Boutique Hotel

Strand Road, Derry City

HED Design Revisions

GENERAL COMMENT — HED REQUIREMENTS
Further to the consultation response by Historic
Environment Division —(HED) of DFC we have amended
the drawings to address the issues and concerns
raised by (HED). We will address each in turn.

HED CONCERNS / QUERIES:

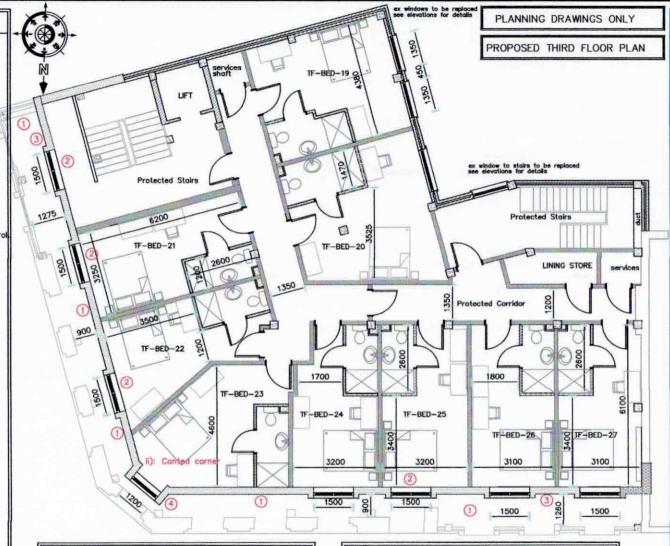
- Rooftop plant rooms removed as requested.
 The M&E consultants will design heating, extraction ventilation and other M&E works within the building.
- ii): Canted corner articulated on new levels 3 & 4. We have now redesigned the 3rd & 4th floors to provide a canted corner with a 600mm wide window spanning both levels.
- iii): The brick built bays are brick cavity walls and are not as thick as the stone walls, therefore this lends to a different line at these bays. We are of the opinion the 350mm step out of the new Zinc Clad wall will positively impact the elevations, creating interest.

The external face of our new Zinc Clad walls will be set back 900mm from the face of the balustraded parapet.

Whilst HED have mentioned 1000mm set back we trust that 900mm is acceptable, as our bedrooms on levels 3 & 4 are reduced in depth due to this setback requirement.

The area between the new Zinc Clad wall and the rear of the balustraded parapet will be weather proofed by a Trocal Flat roof. We are not providing access to this area from the bedrooms.
